PHP - Technical Bulletin

Bulletin Number: TB-140201 **Subject:** PHP-23A ECU Updates

Issue Date: Feb. 25, 2014 (Revised March 18, 2020)

Scope: PHP-23A Heaters Manufactured Prior to 2013

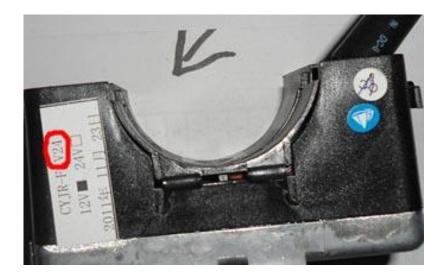
All current glow pins and ECUs in our inventory are of the improved version. The version of ECUs can be identified by the Version Number Stamped on them (Refer to image below). The improved versions are marked with V26 or higher.

This problem does not affect all heaters and heaters should only be modified if they fail prematurely. When detecting a glow pin failure, check the version of ECU. If the Version is V25 or less, the ECU should be replaced along with the glow pin. ECUs do not need to be replaced if they are version V26 or higher.
